**DATE** June 10, 2013**PROJECT No.** 12-1151-0213**TO** Mr. Jeffrey Lee  
Town of Oakville**CC** Mr. John Bayliss, Mr. Scott Winger**FROM** Tracy Hodges, Golder Associates**EMAIL** tracy\_hodges@golder.com**RESPONSE TO PEER REVIEW – PHASE 2 OF COMPLETE APPLICATION – BRONTE ASPHALT PLANT  
OAKVILLE HEALTH PROTECTION AIR QUALITY BY-LAW APPLICATION FOR APPROVAL**

This memo is to provide additional clarification of information as requested in the Town of Oakville Peer review letter received on May 22, 2013 from XCG Environmental Engineers and Scientists (XCG) regarding the Phase 2 Review of the Application for Approval for Dufferin Construction Company's Bronte Asphalt Plant.

**FIGURE: 2**

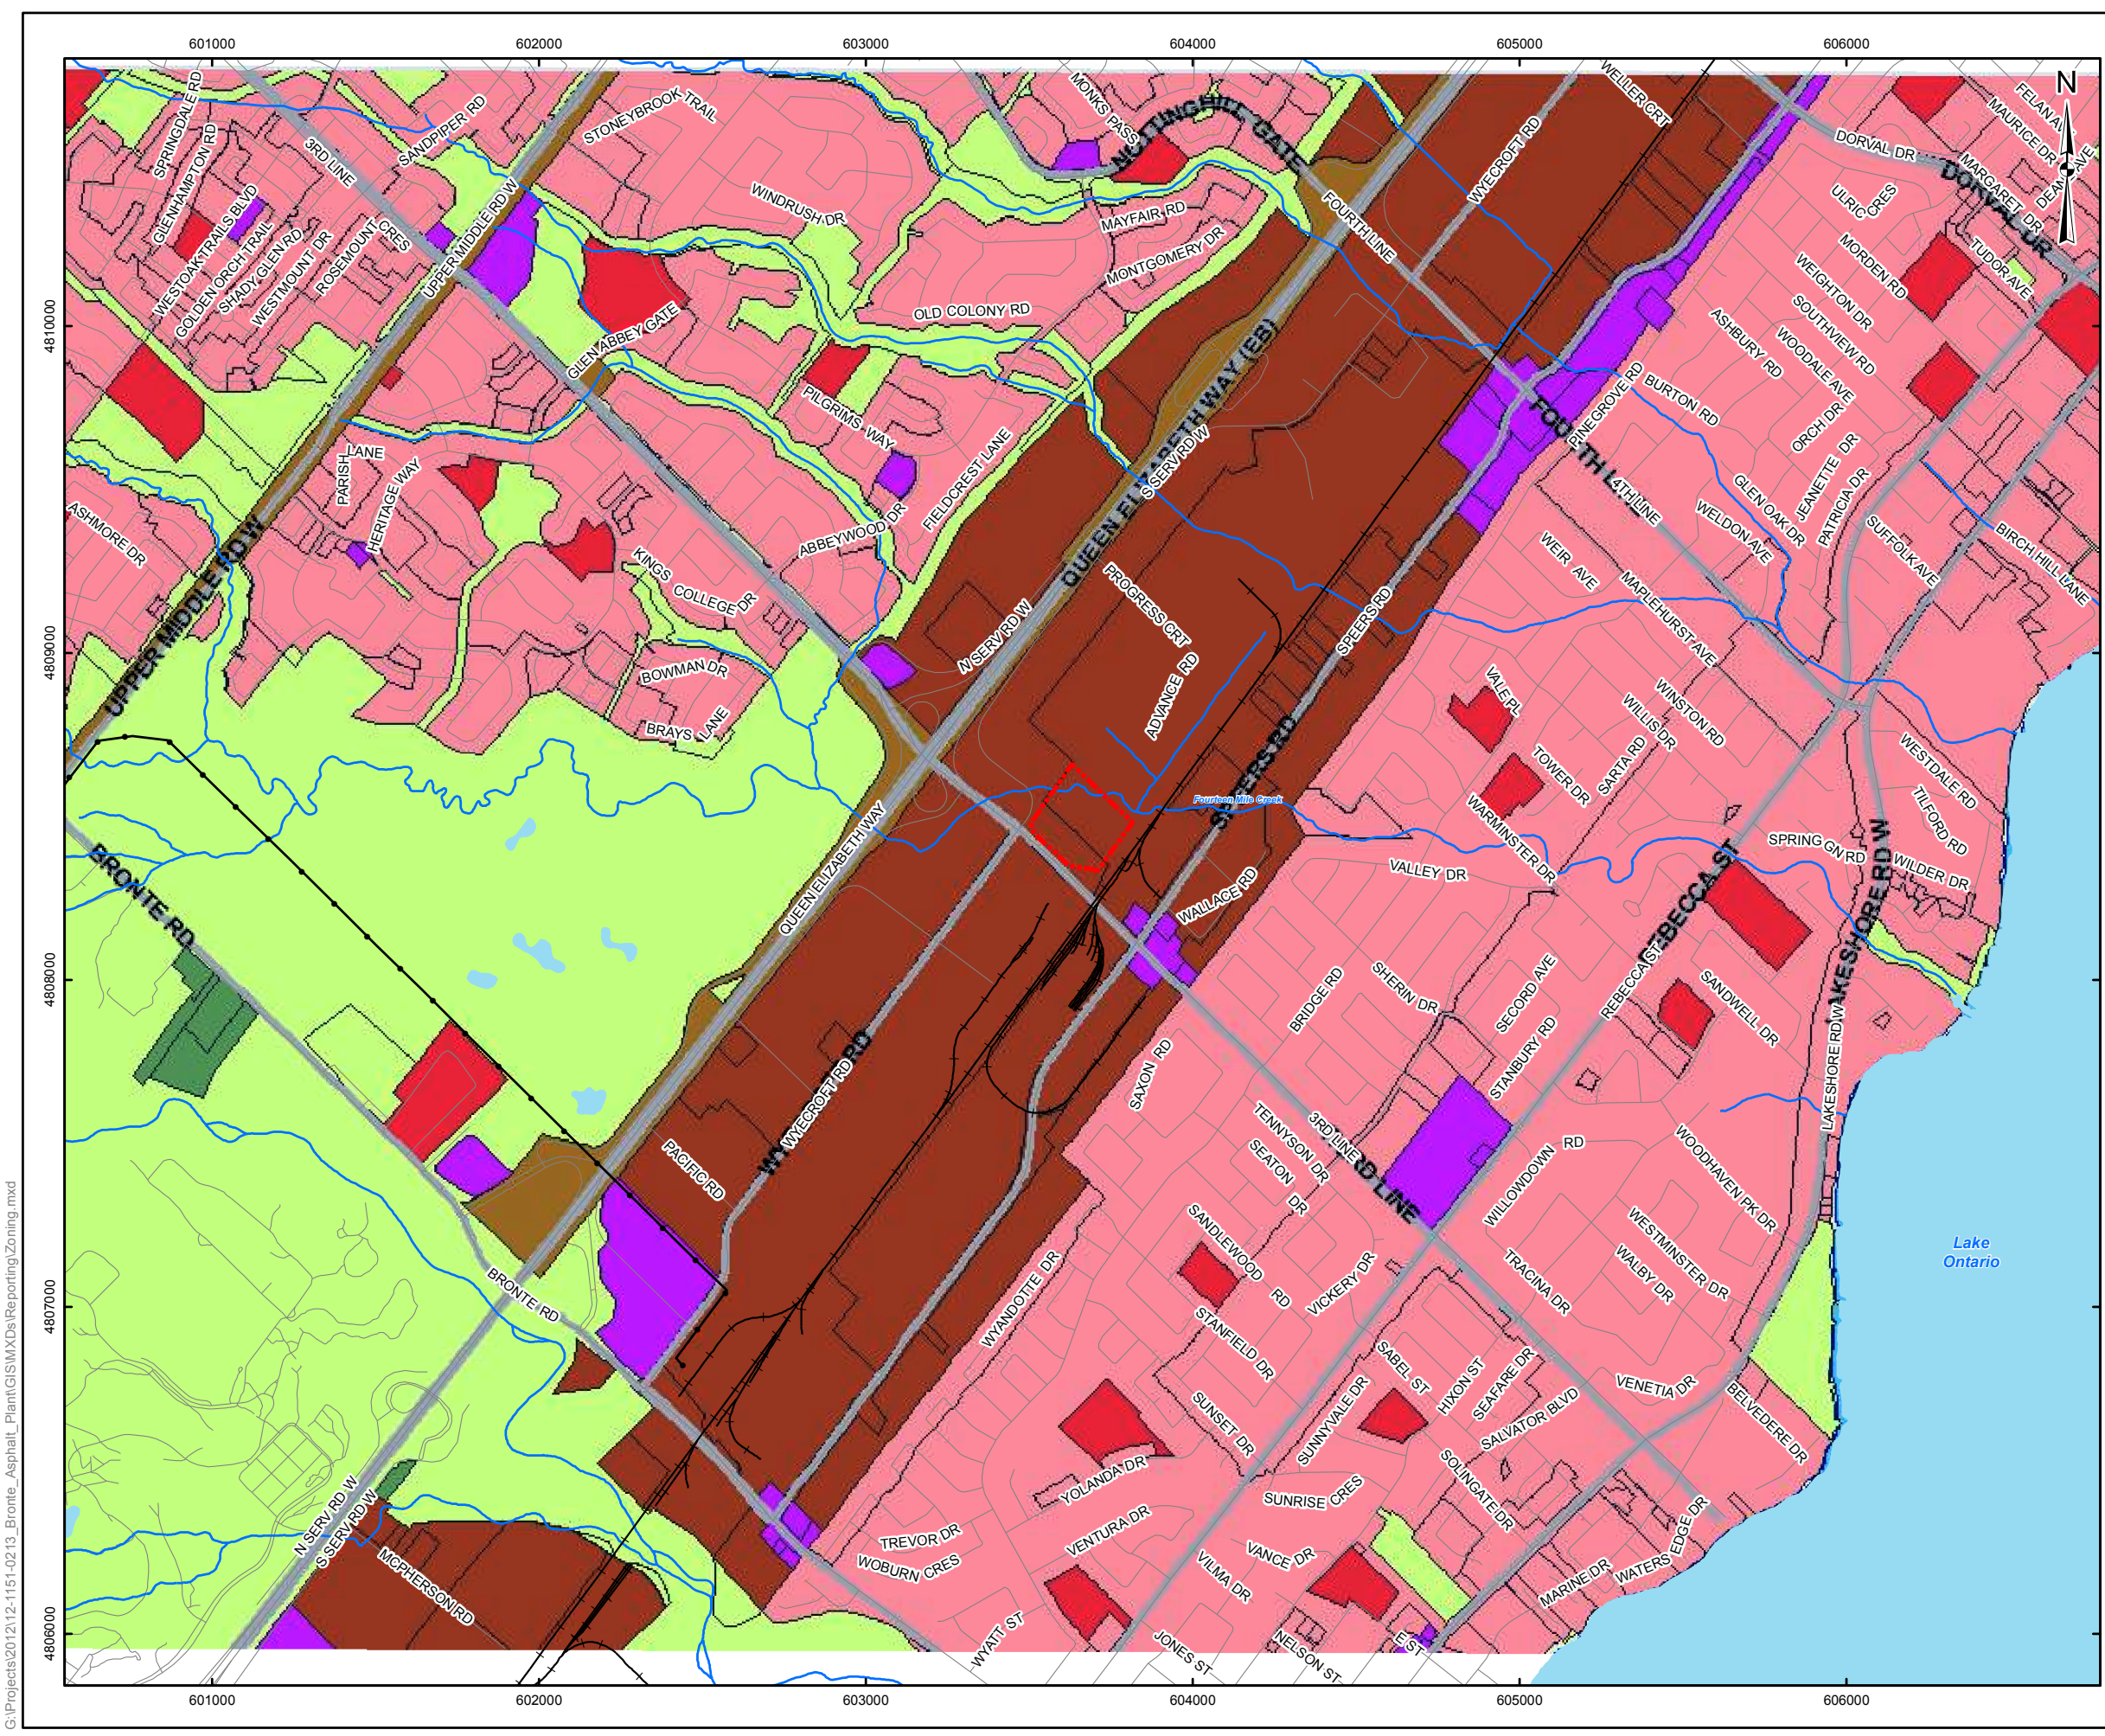
Application Item	Elaboration of Application Item	Issues Raised in Phase 2 Review Comments	Response
3.2 Location	<p>Provide facility address and at least two location in the town; and, (ii) details in the environs within 3 kilometres of the facility (site). All maps must clearly identify the facility and its surroundings. The details map(s) should include nearby significant sources (e.g., highways, major roads) of FPM and precursors and sensitive receptors (e.g. health care facilities, schools, and residential areas). All maps must be in UTM/WGS84 datum coordinates. These maps may</p>	<p>Figure 2 shows the land use zoning within a radius of approximately 1.5 km of the facility. Although this figure does not show the full 3-kilometre radius required by the By-Law, the zoning map clearly shows the presence of residential zoning within 450 metres of the facility. School zoning is present within 1 km of the facility. The final document should show the 3-kilometre radius as required</p> <p>XCG has noted that The Sanctuary Church is located at 2009 Wyecroft Road, Oakville. This church is located in a commercial building located approximately 100 metres west of the facility. It does not appear that this church offers any day care activities, and is therefore not considered sensitive.</p>	<p>New map attached with expanded zoning information. This is based on the most recent files available from the Town of Oakville.</p> <p>The Sanctuary Church building identified is not actually a place of worship. This building is the administrative offices for the Sanctuary Church; therefore it is not considered a sensitive receptor.</p>
